**MEMORANDUM**

TO: District of Columbia Board of Zoning Adjustment
FROM: Arthur Jackson, Case Manager
 Joel Lawson, Associate Director Development Review
DATE: January 8, 2013
SUBJECT: BZA Case 18487 - request for variance relief from §§ 402.4, 403.2, 404.1 and 2001.3 (a) and (b) for an addition to the three-story row dwelling (flat) located at 1751 18th Street NW

BZA Application No. 18487
1751 18th Street NW

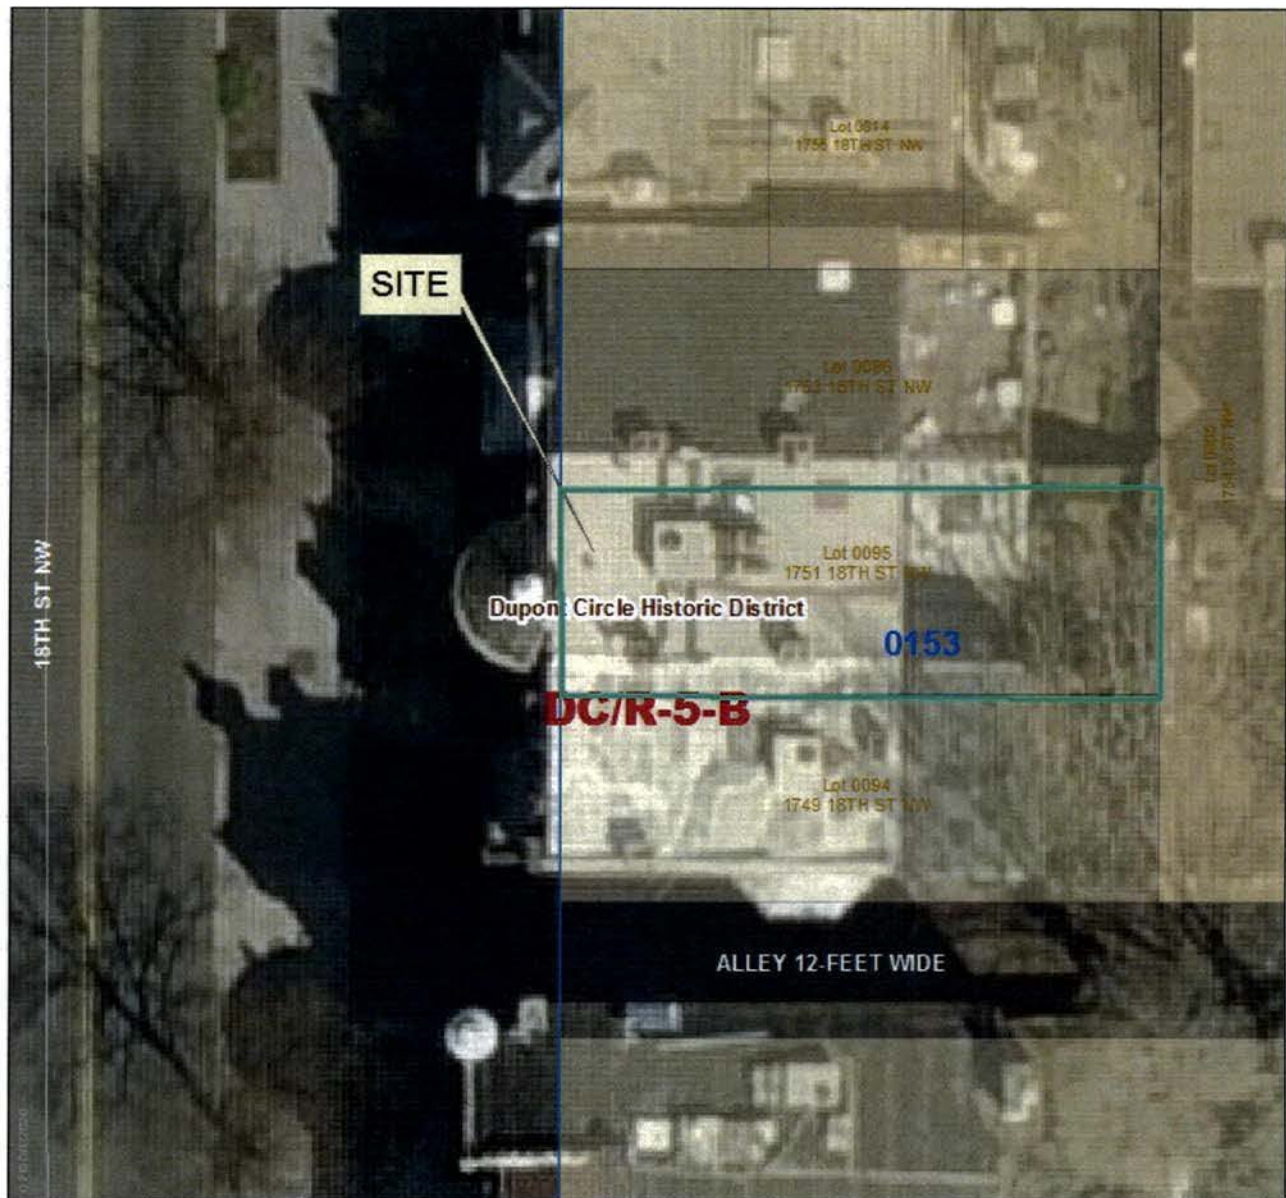
A review of the lots on Square 0153 revealed that the subject property (and the adjacent identically-sized properties at 1749 and 1753 18th Street, lots 0094 and 0096, respectively) are among the smallest lots on the square. Thus the minimal size of these lots makes them unique (refer to Figure 2). While the L-shape floor plan does not appear unique on this square, widening the rear addition could significantly enhance the practical use of the limited space.
